CPSES-200102851
Log # TXX-01196
File # 10010.1
905.2

November 30, 2001

SUBJECT: COMANCHE PEAK STEAM ELECTRIC STATION (CPSES)
DOCKET NOS. 50-445 AND 50-446
SUPPLEMENT TO RELIEF REQUEST B-1 AND C-1
FROM INSERVICE INSPECTION REQUIREMENTS
(1986 EDITION OF ASME CODE, SECTION XI, NO ADDENDA;
UNIT 1 SECOND INTERVAL, FIRST PERIOD, FIRST OUTAGE
DATES: AUGUST 3, 2000 TO AUGUST 3, 2010)

LIMITATION AND WELD PROFILE EXAMINATION DATA

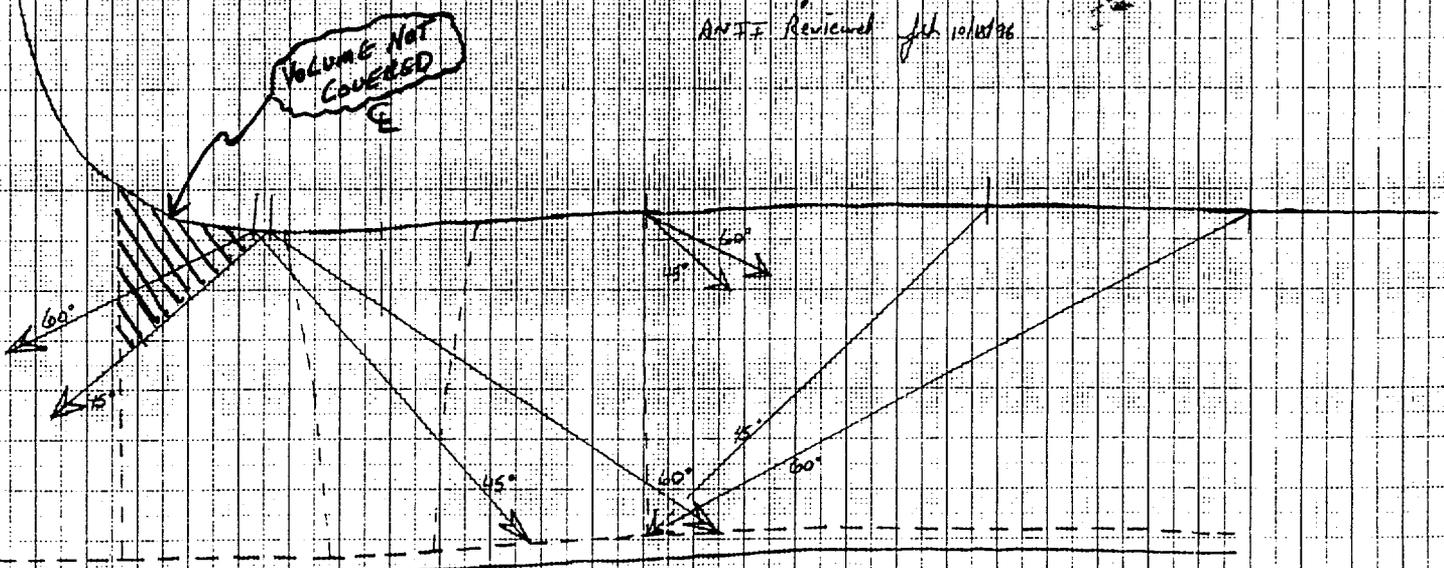
- 3) The weld profile sketches list three different coverage percentages at the bottom - which one applies?

4) Sketches do not show areas of incomplete coverage

They all apply. See below:

Previous sketches provided show the incomplete coverage. The area not covered begins left of the centerline at the start of the 60 ° beam angle. A shaded area figure, which depicts area not covered, is being provided in the attachment.
